Proposed Revisions to a Standard Plans Index

Index Number: 641-020

Index Title: CONCRETE CCTV POLE

SHEET
2 of 5

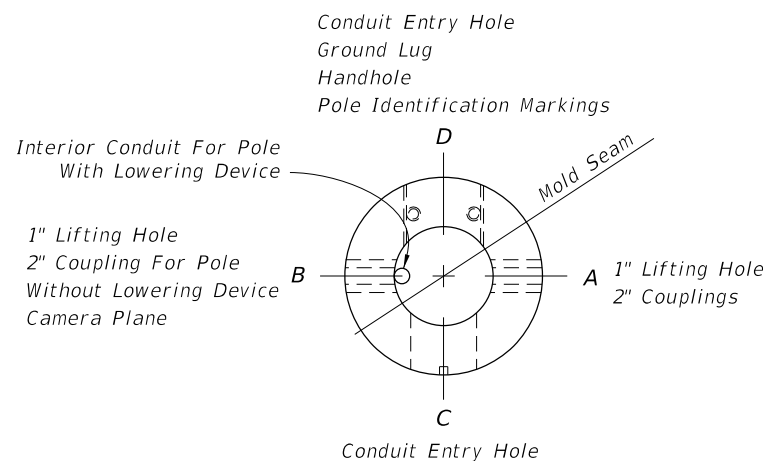
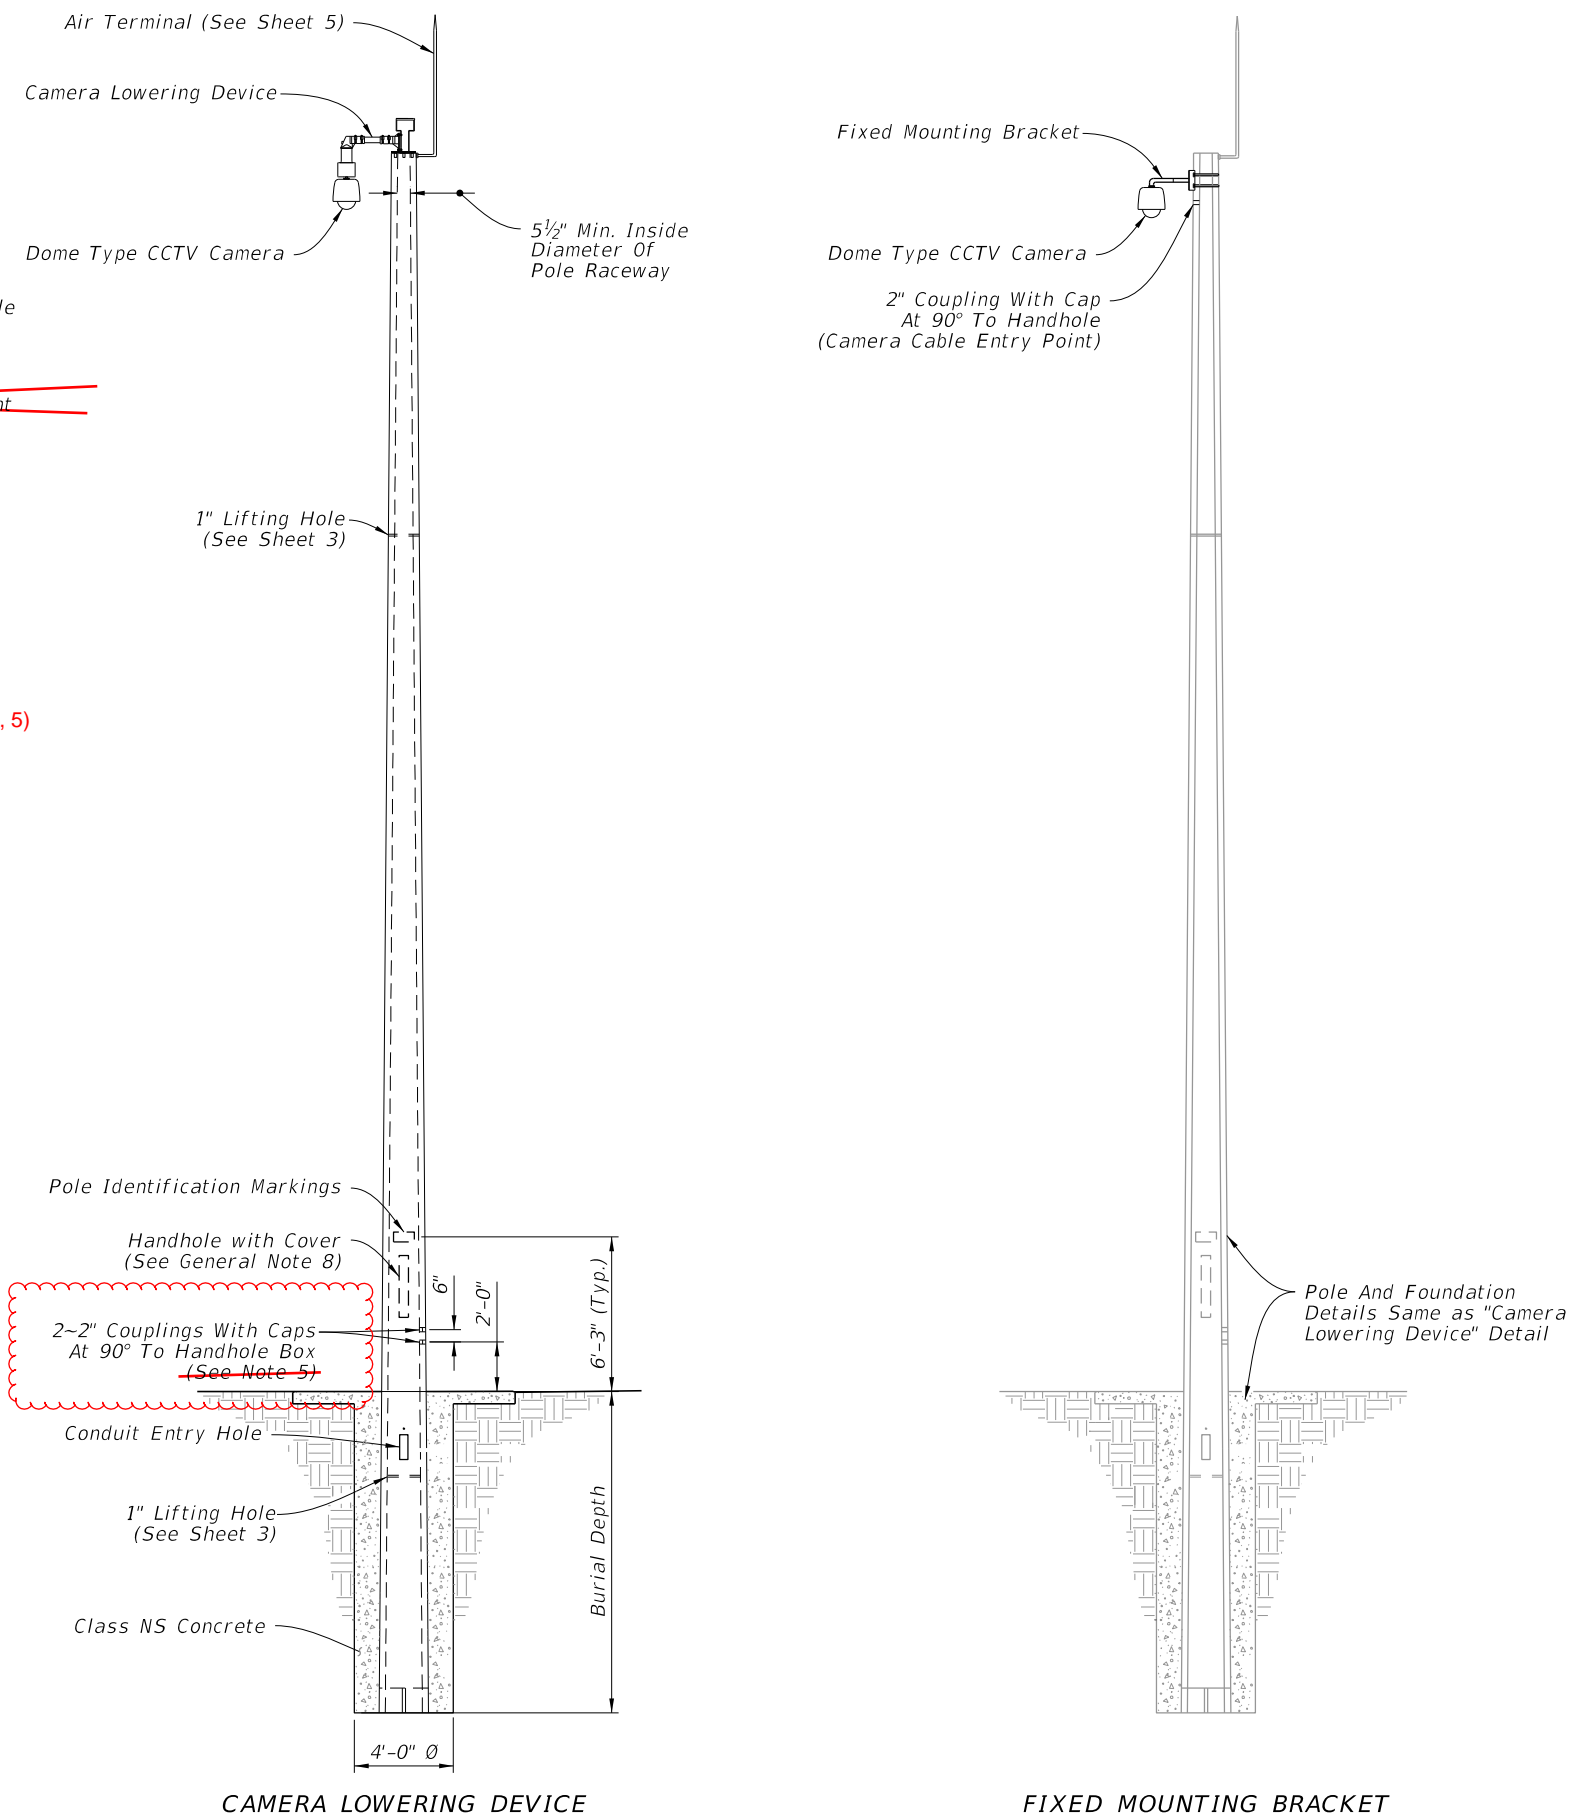
Sheet 2: Added note allowing additional strand pattern and updated associated tables.

5. Strand Pattern 1 may be used in lieu of Strand Pattern 2 where required by fabrication to facilitate Handhole construction.

SHEET
3 of 5

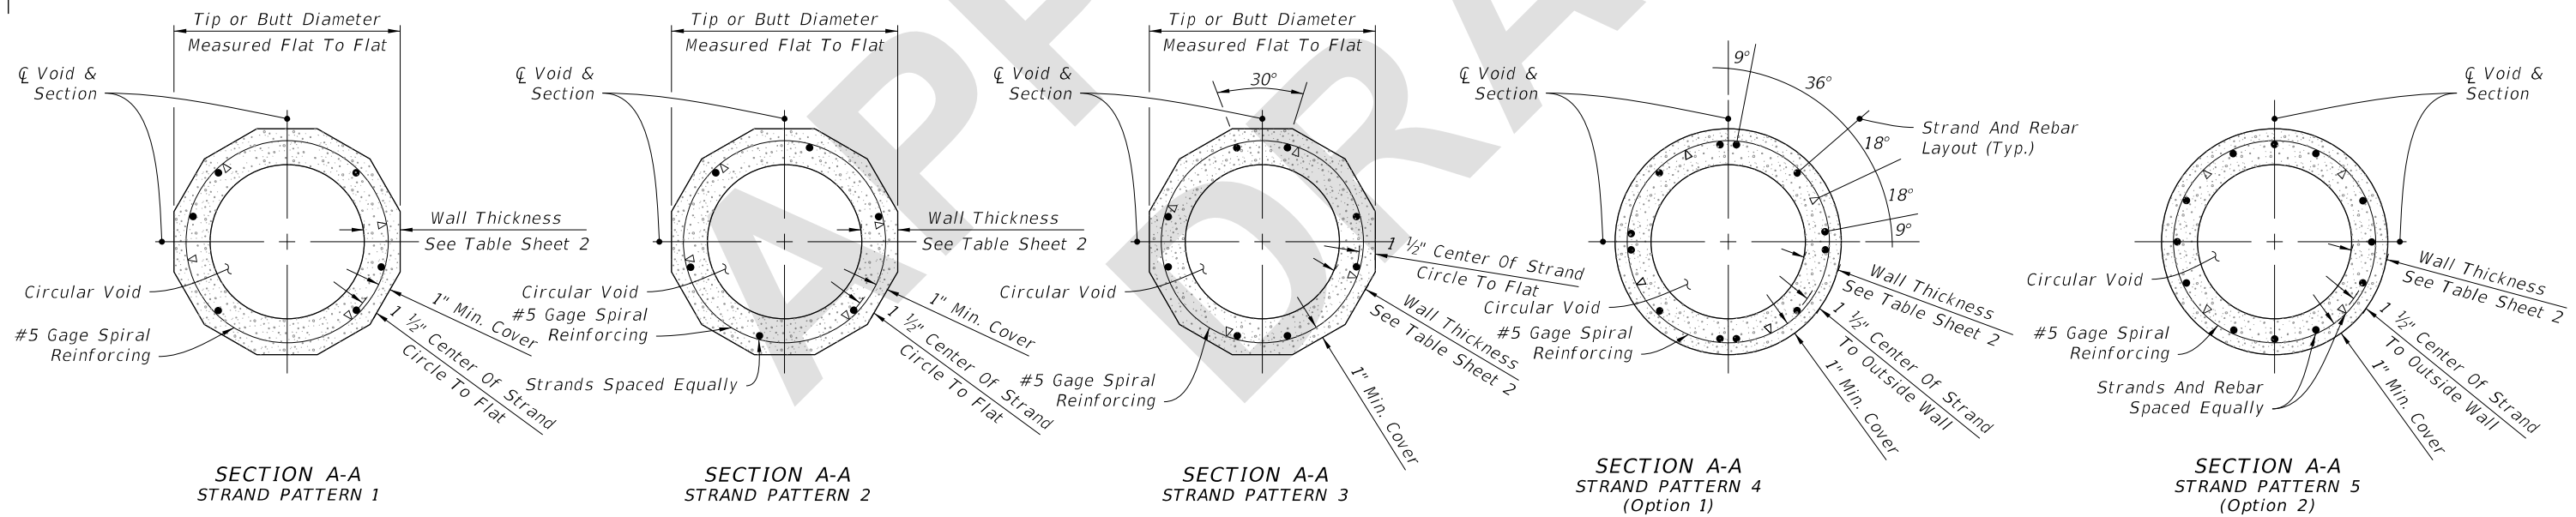
Sheet 3: Added a new strand pattern.

Sheet 3: A fabricator of 12 sided poles had an approved strand pattern in their QC plan which differed from the Standard. The difference allowed the fabricator to mount the hand hole on the flat of the pole and maintain reinforcement cover. We have adopted this in the Standard to provide consistency between the QC plan and the Standard.

Added New Strand Pattern Detail
